IN THE MATTER OF AN APPLICATION TO
AN BORD PLEANÁLA

FOR APPROVAL OF (I) THE N6 GALWAY CITY RING ROAD
PURSUANT TO SECTION 51 OF THE ROADS ACT 1993 (AS
AMENDED); (II) THE N6 GALWAY CITY RING ROAD
MOTORWAY SCHEME 2018; and (III) THE N6 GALWAY CITY
RING ROAD PROTECTED ROAD SCHEME 2018

ABP Ref. ABP-302848-18 and ABP-302885-18

STATEMENT OF Evidence
Responses to Hydrogeology
Objection/Submissions

Job No	Drawing No	Issue
233985-00	Figure 10.5.001	I2

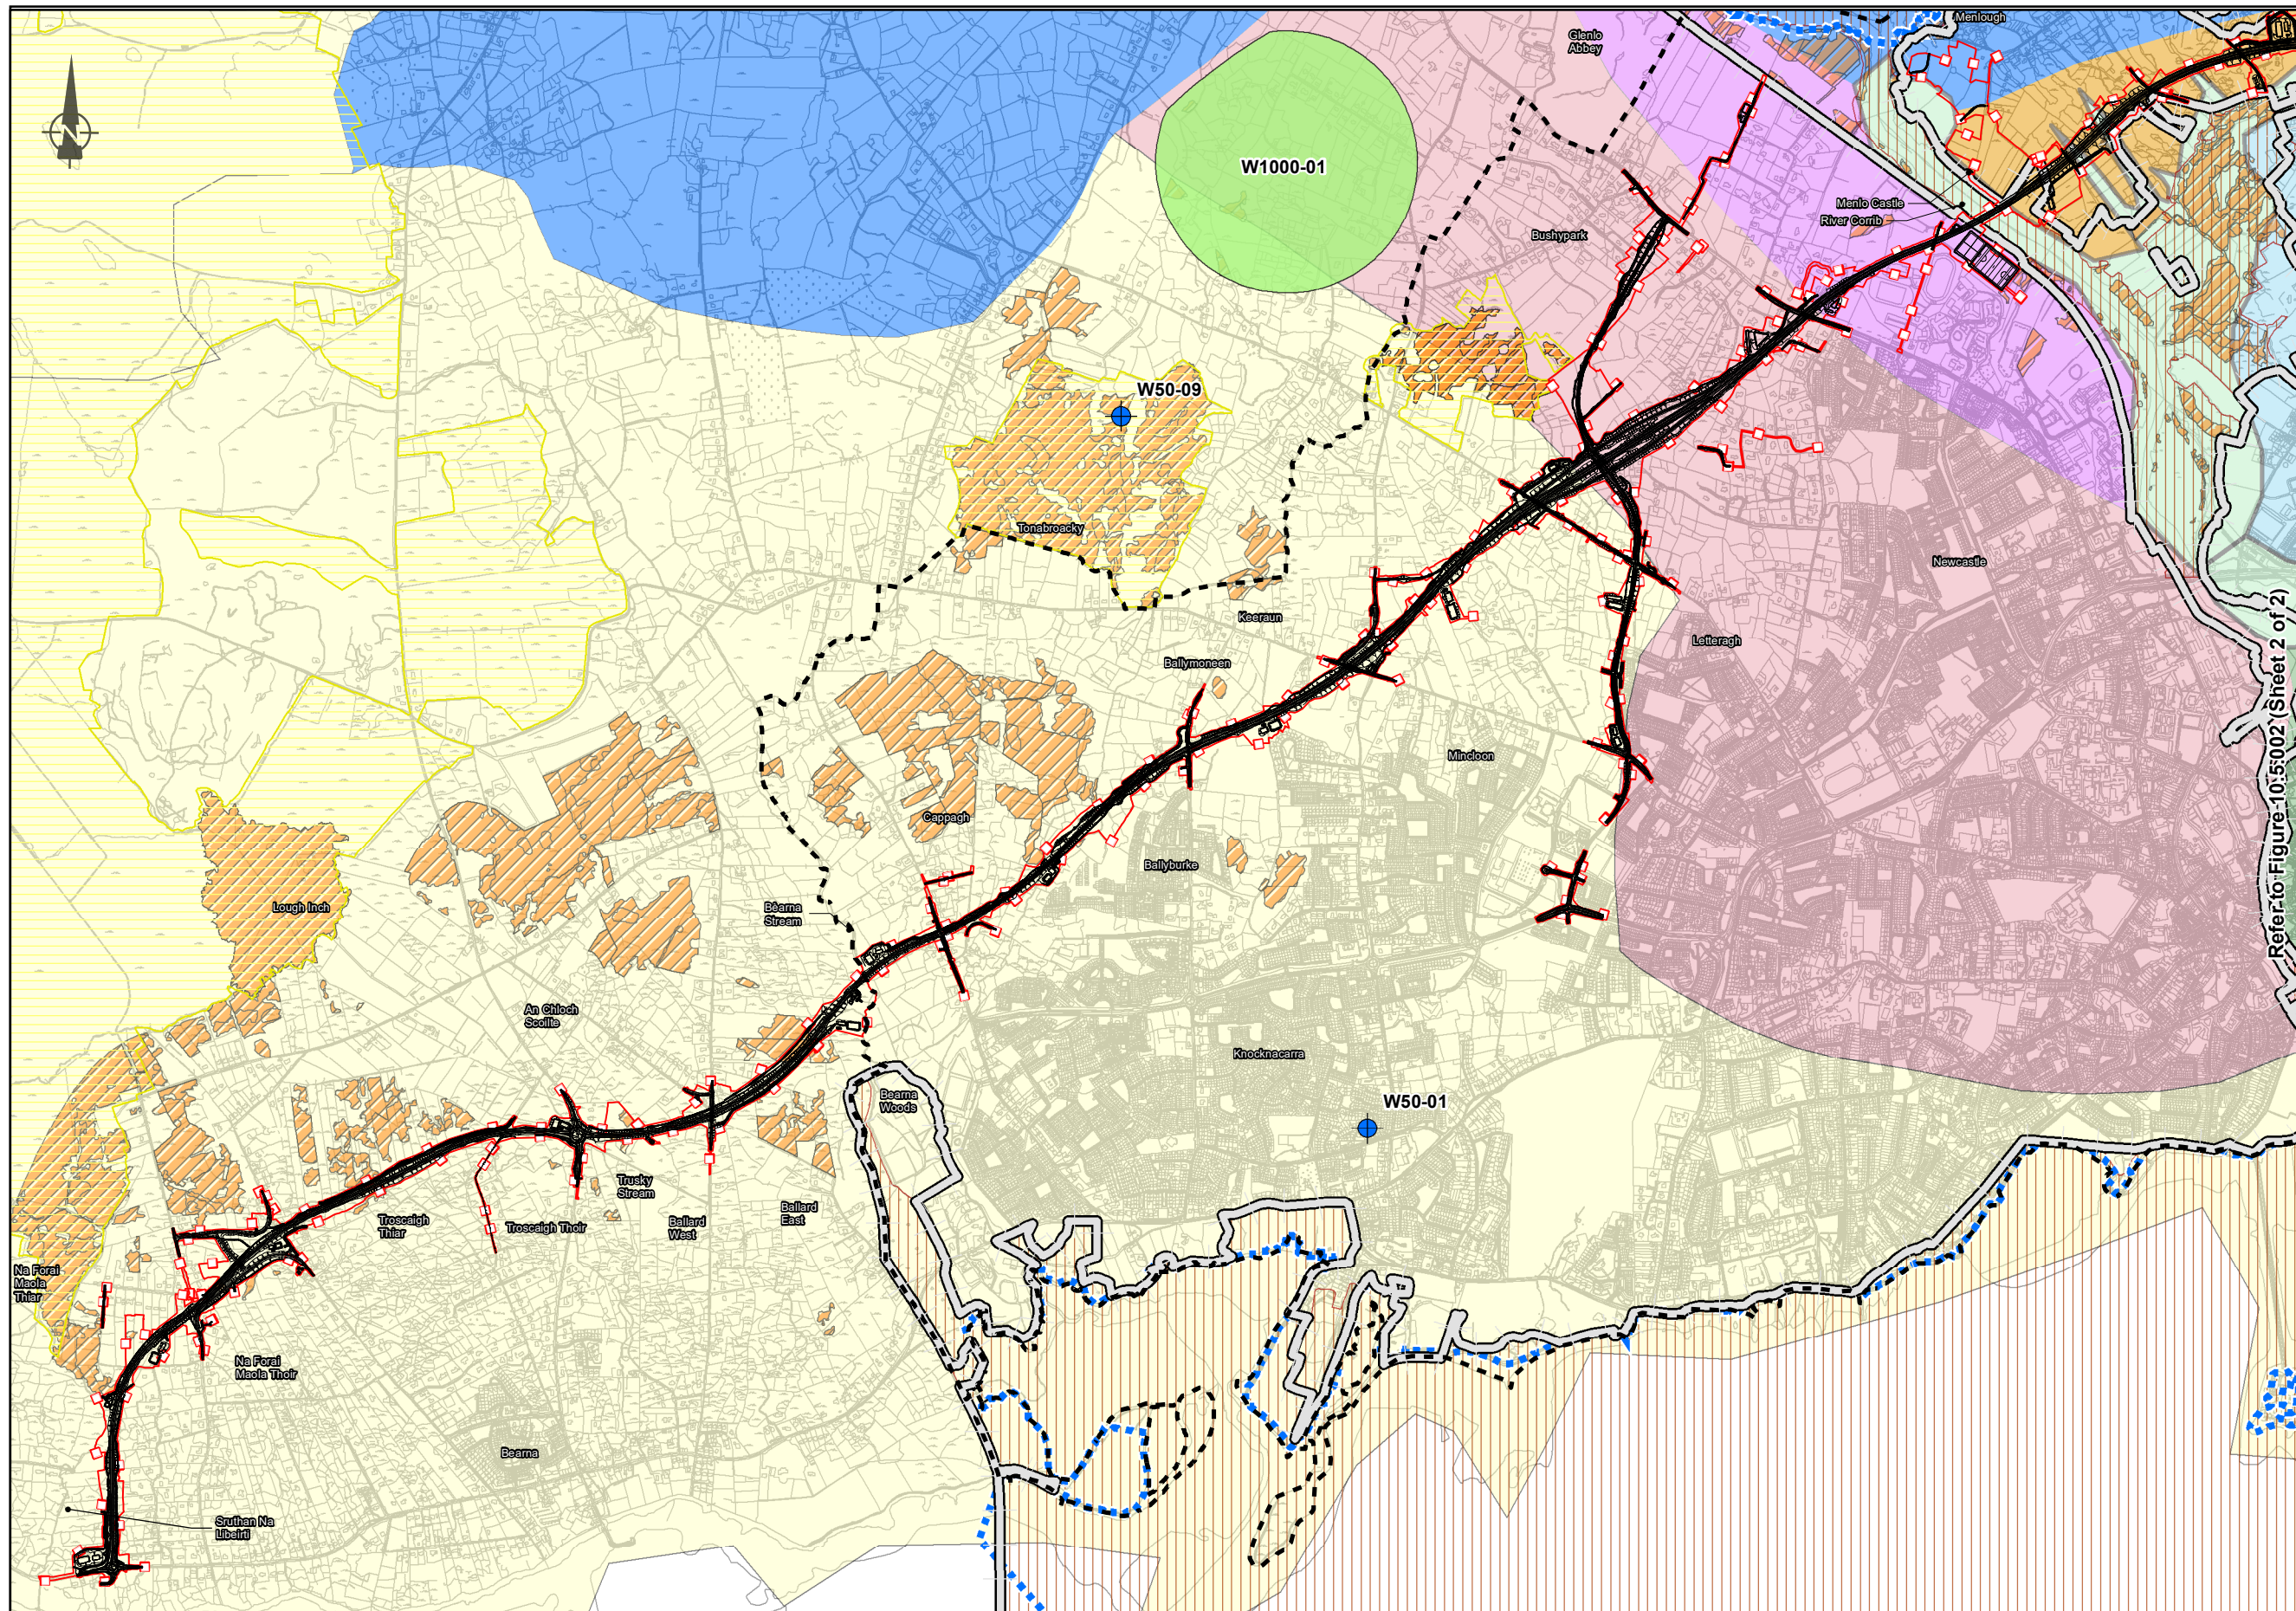
EIAR Figure 10.5.001 and Figure 10.5.002 show the Spiddal and Maam-Clonbur groundwater bodies have been coloured incorrectly

EIAR Figure 10.5.001 has been amended to include the following:

Job No	Drawing No	Issue
233985-00	Figure 10.7.101	I2

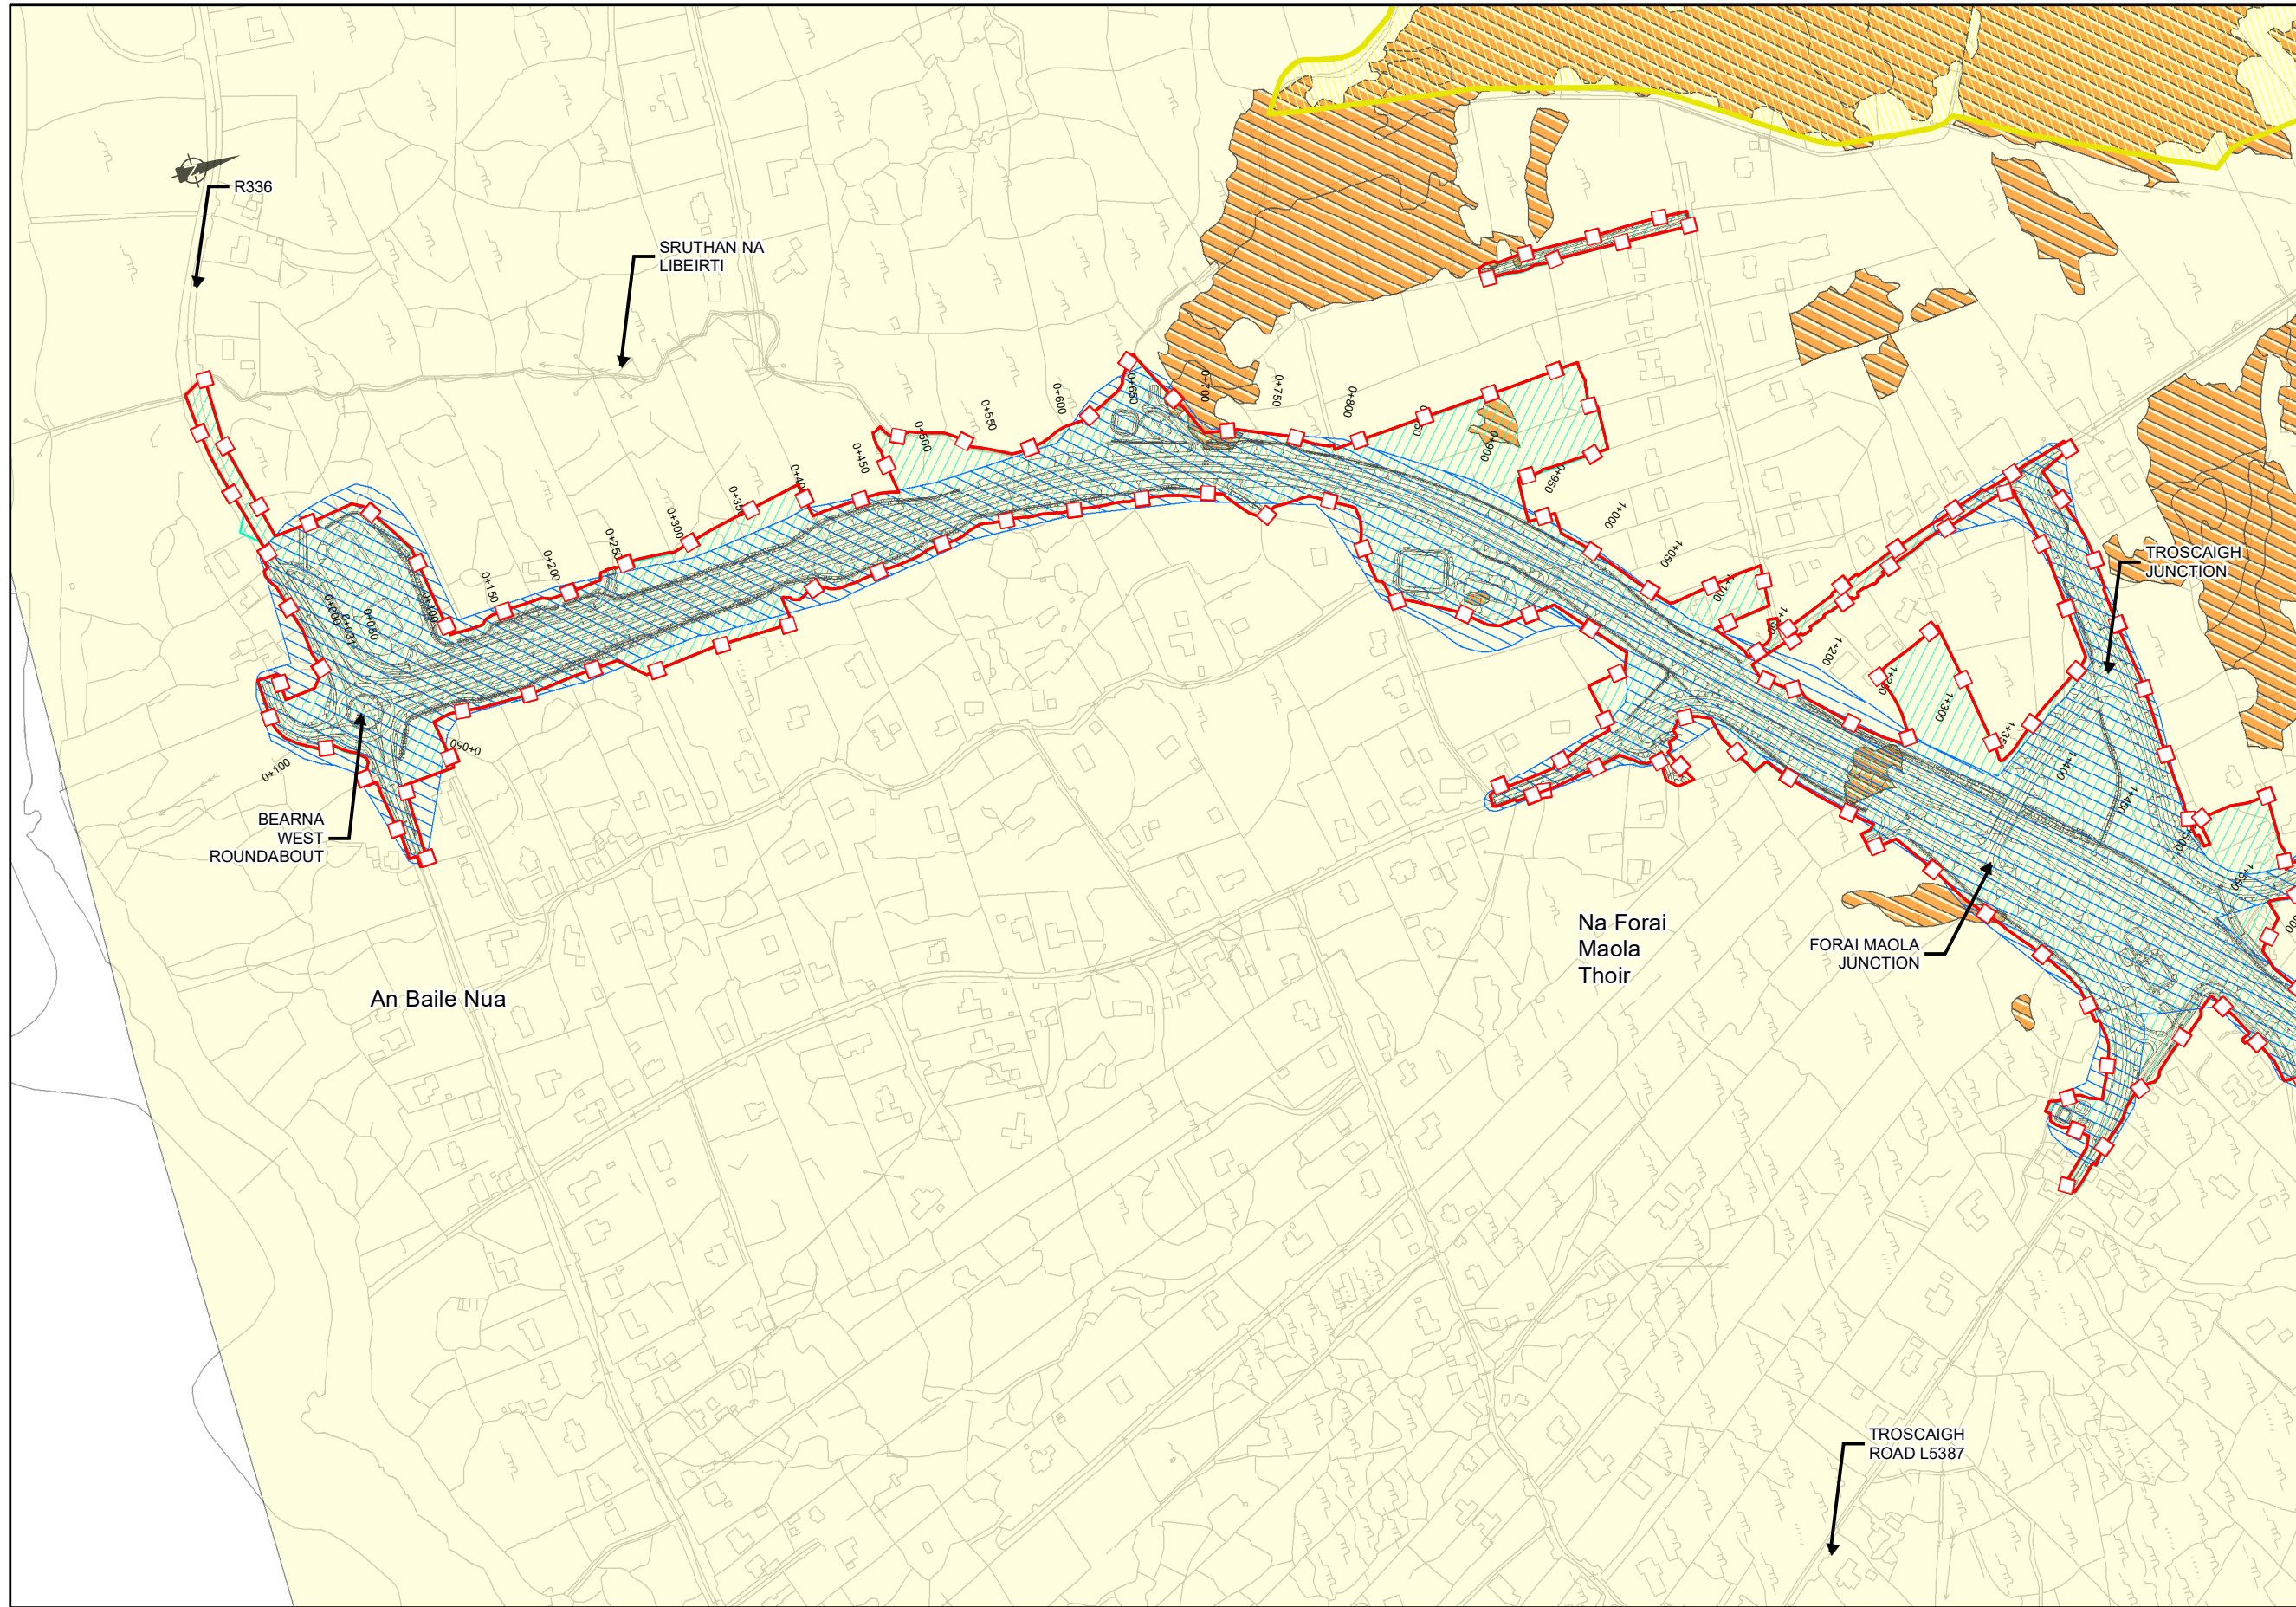
EIAR Figures 10.7.101-106 show the Spiddal and Maam-Clonbur groundwater bodies have been coloured incorrectly.

EIAR Figure 10.7.101 has been amended to include the following:

Job No	Drawing No	Issue
233985-00	Figure 10.8.101	I2

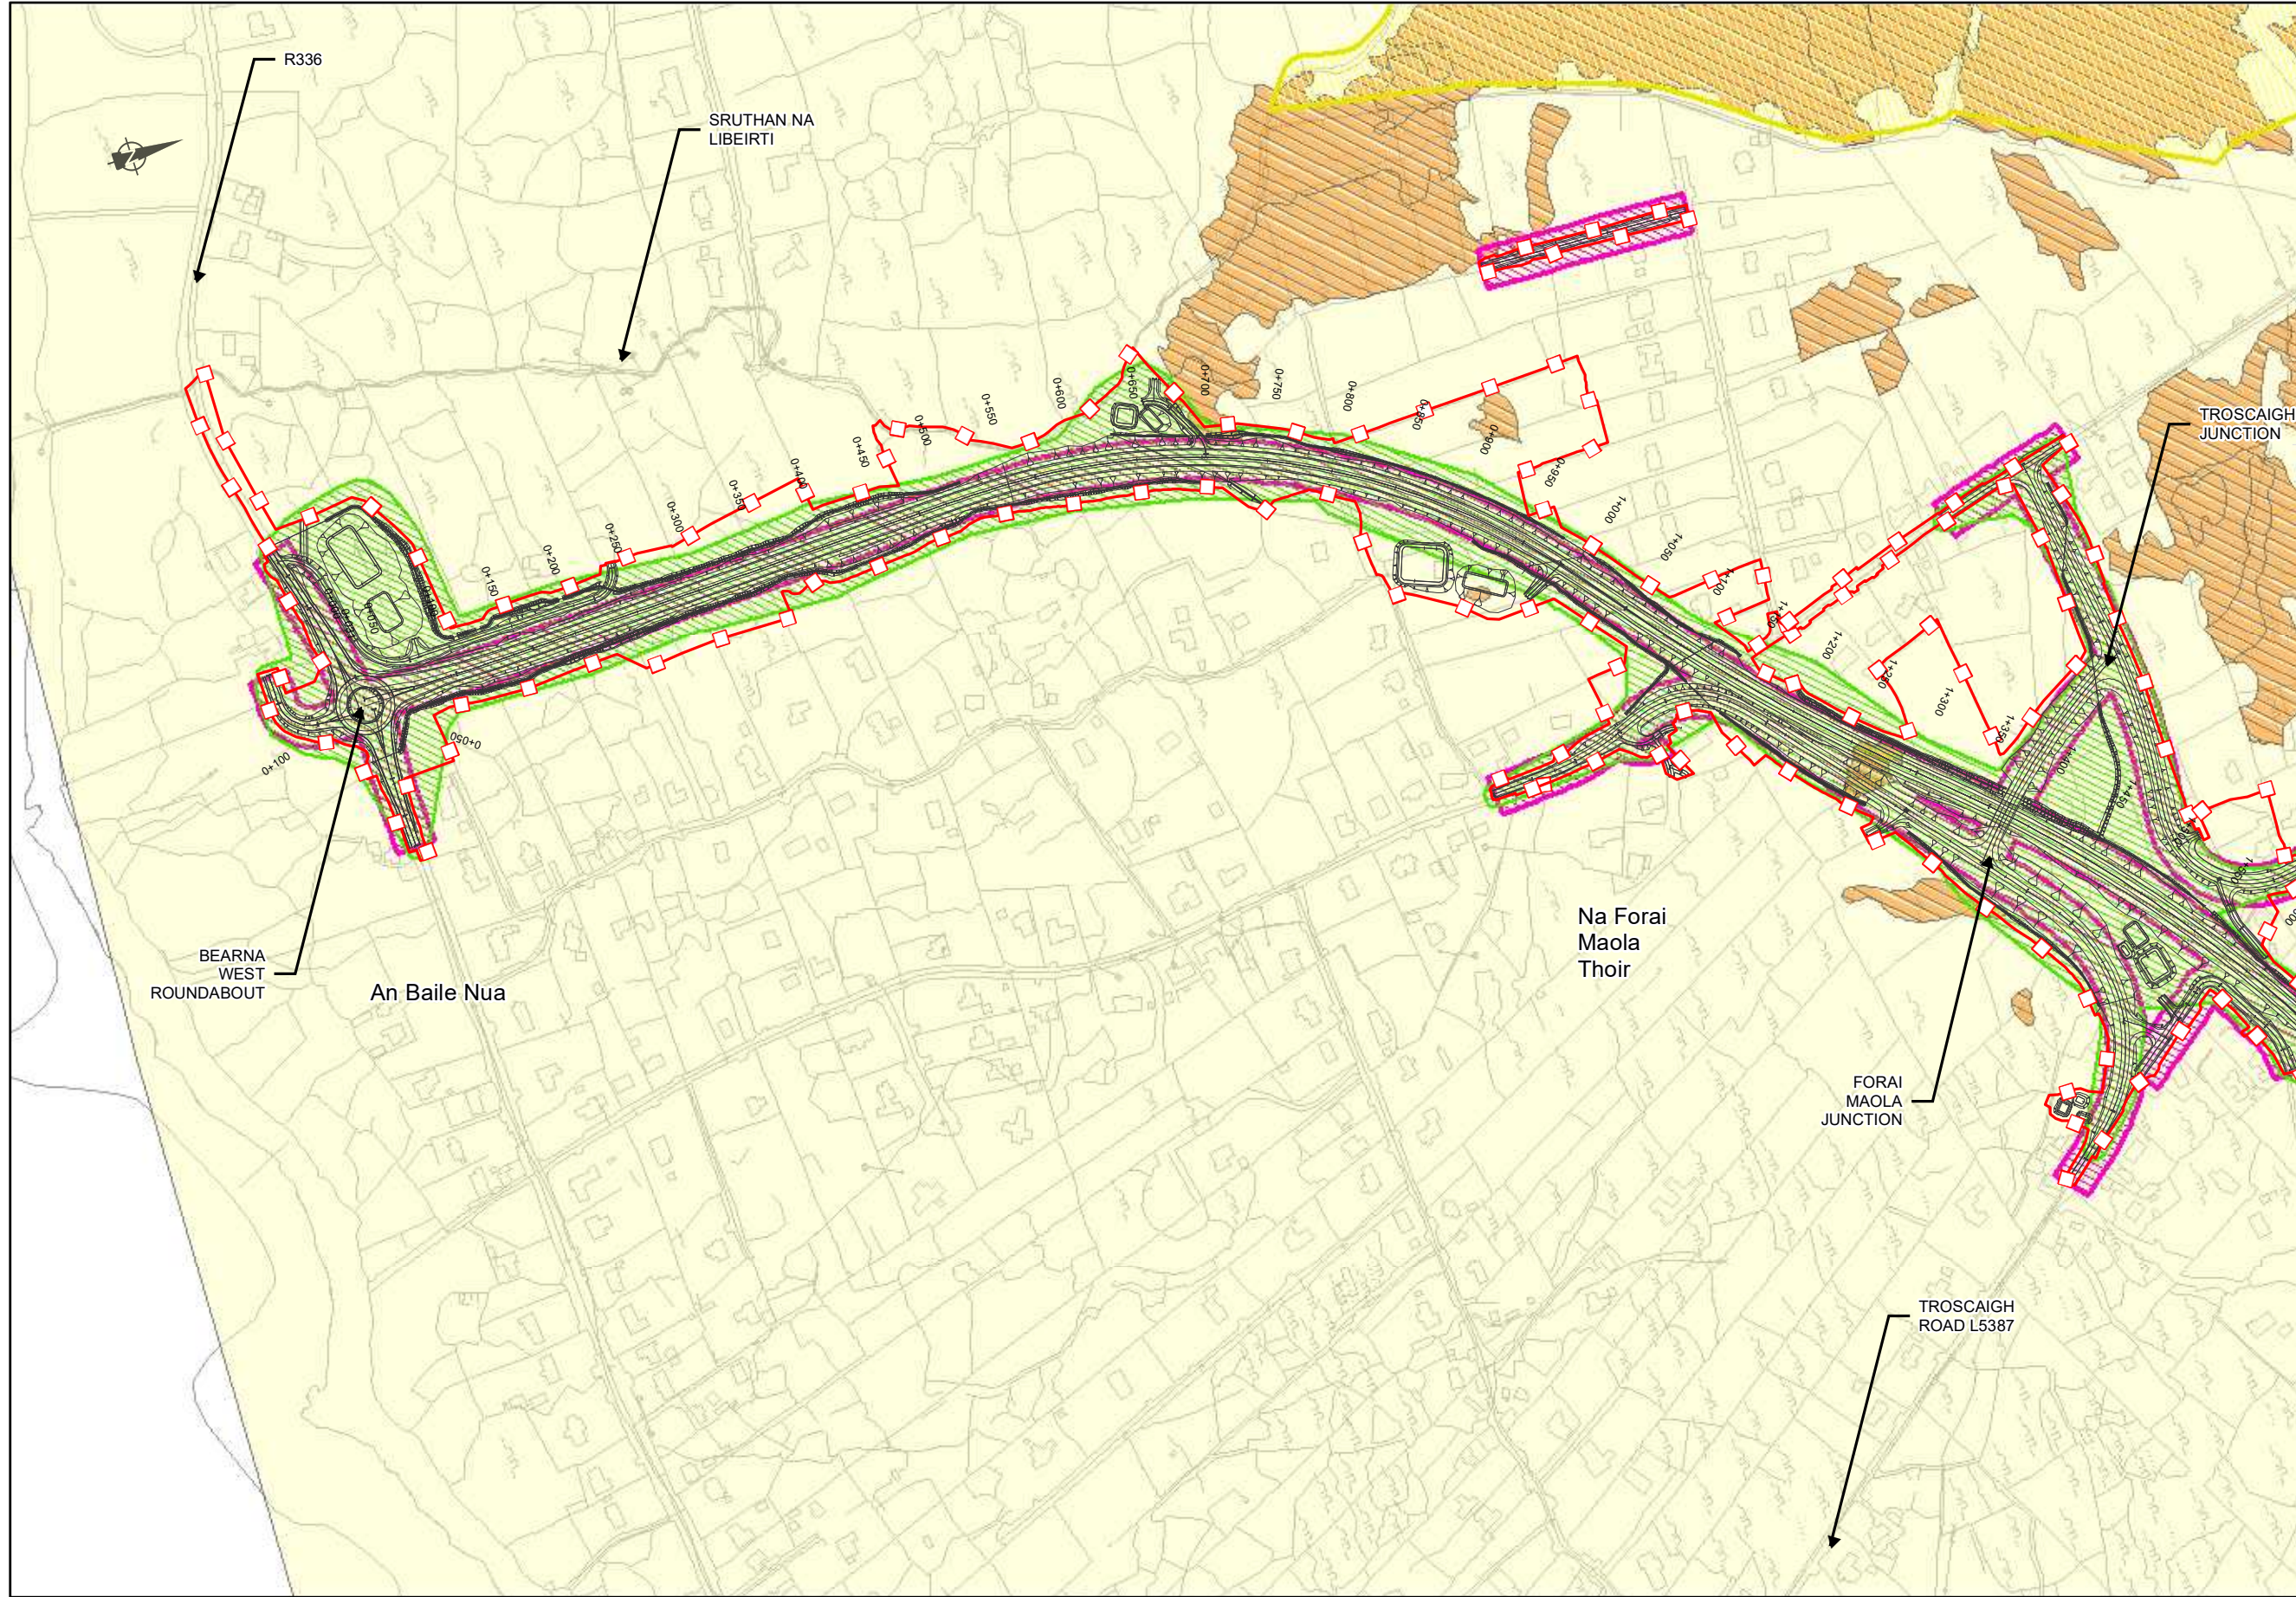
EIAR Figures 10.8.101-106 show the Spiddal and Maam-Clonbur groundwater bodies are coloured incorrectly

EIAR Figure 10.8.101-106 has been amended to include the following:
